Planning Commission Packet

I. LU 2023-017 SP/CUP ROCK CREEK INDUSTRIAL (PANATTONI) - Continued

Rock Creek Industrial (Panattoni)
SITE PLAN REVIEW & CONDITIONAL USE PERMIT
LU 2023-017 SP / CUP

Sheet Title:
LANDSCAPE PLAN

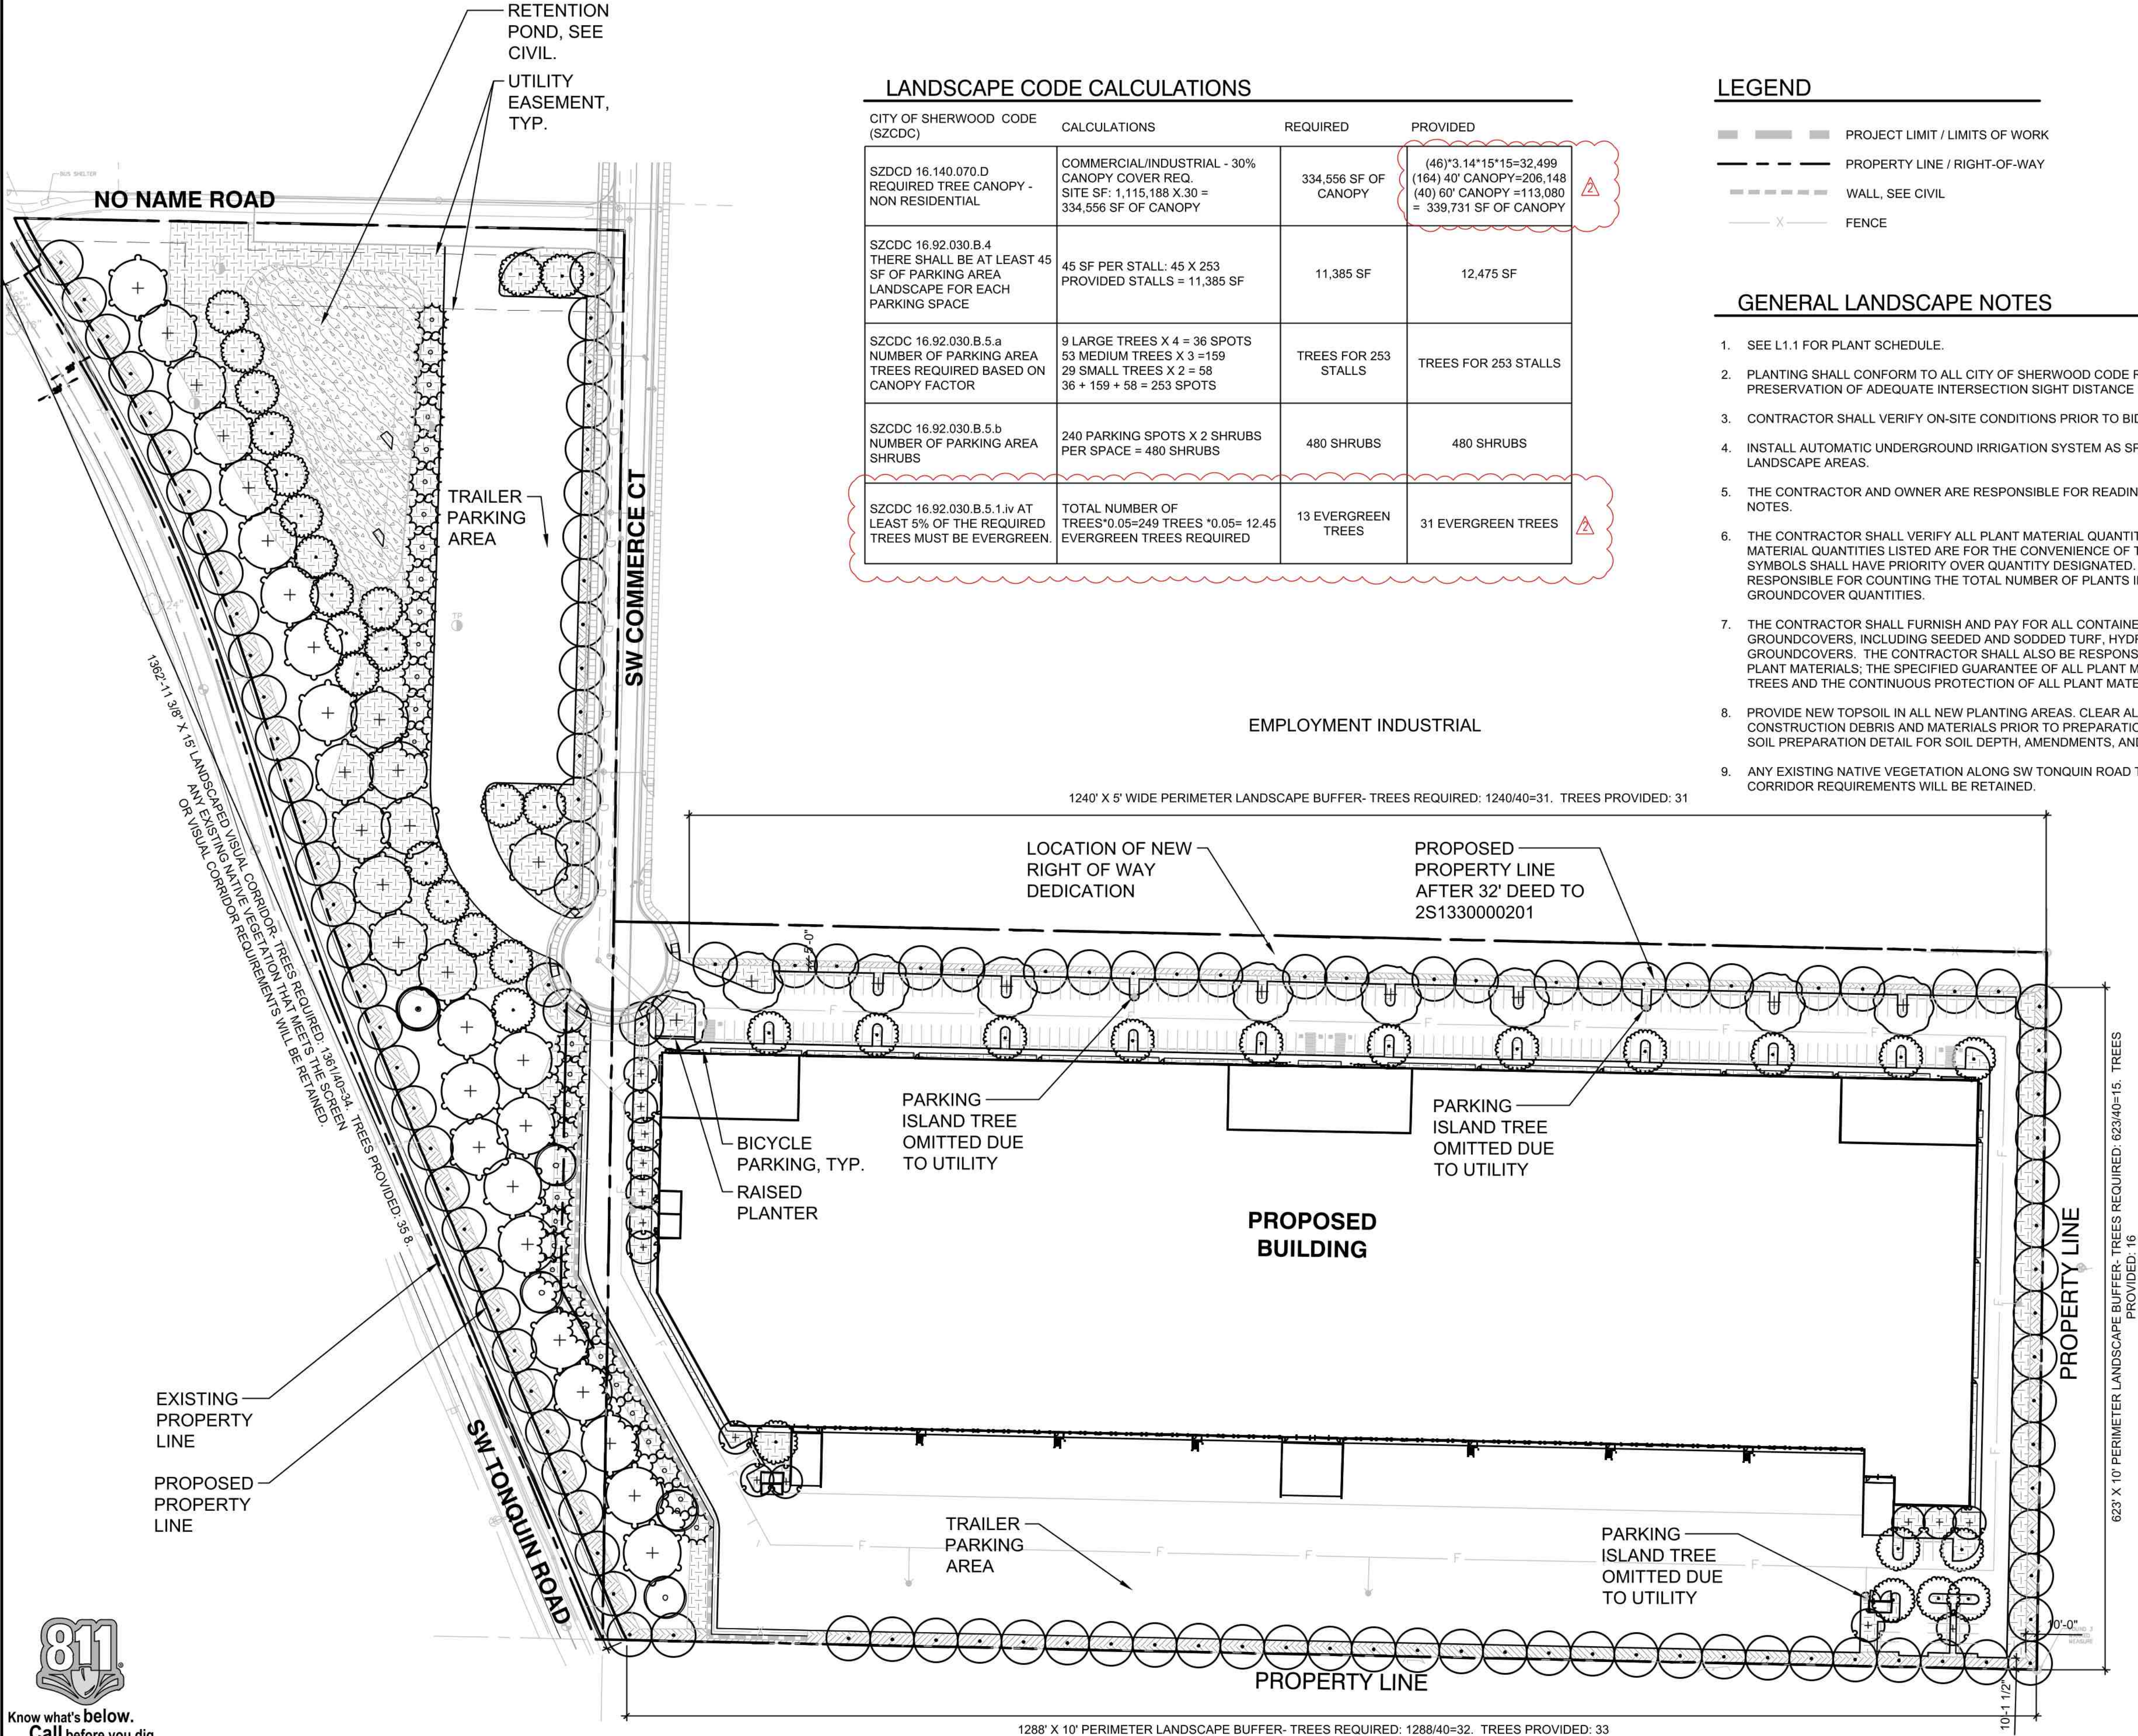
Prior to the March 12, 2024, second evidentiary hearing, the applicant provided an updated landscaping plan, Attachment A, Appendix J.1, indicating additional evergreen tree landscaping will be provided along western property line, abutting SW Tonquin Road. Approximately 34.06 percent of the proposed 91 required trees, pursuant to 16.92.030, will be evergreen, exceeding the standard; the overall percentage of evergreen trees located on the subject parcel(s) will be approximately 12.45 percent. A condition of approval was removed as a result of this resubmission, as the applicant displayed compliance with the applicable code criterion, pursuant to 16.92.030.B.5.a.1.iv; conversely the applicant did not provide evergreen planting at the southern property line, and a condition of approval was added to address Planning Commission concerns. These alterations are indicated as follows:

FINDING: Portions of the proposed ground coverage landscaping do not appear to be consistent other submitted materials or in compliance with this code section as detailed under sheet L.1 – Landscaping Plan. Conversations with the applicant indicated that this portion of the site will consist of existing vegetation. Additionally specific ground coverage was not defined within their landscaping details. No mulch or landscaping substitute is proposed. The following conditions apply to satisfy the above criteria:

Condition B.13: Prior to Final Site Plan Approval, the applicant shall resubmit landscaping plans indicating the placement of proposed perimeter landscaping trees along the southern boundary of the property consisting of a ratio of 1:3 evergreen. These shall be evenly distributed along the parcel(s).

Condition B.3: Prior to Final Site Plan Approval, the applicant shall submit a revised landscaping plan indicating that all areas not planted with trees and shrubs will be planted in ground cover plants, excluding mulch or other similar materials. Existing landscaping posed for preservation shall be clearly delineated on the plans.

Condition B.4: Prior to Final Site Plan Approval, the applicant shall submit a revised landscaping plan, detailing the species and type of all ground coverage utilized on the subject parcel(s); the proposed ground coverage shall be least four-inch pot size and reach a density that will cover the entire area within three (3) years from the time of planting, pursuant to 16.92.020.A.1.
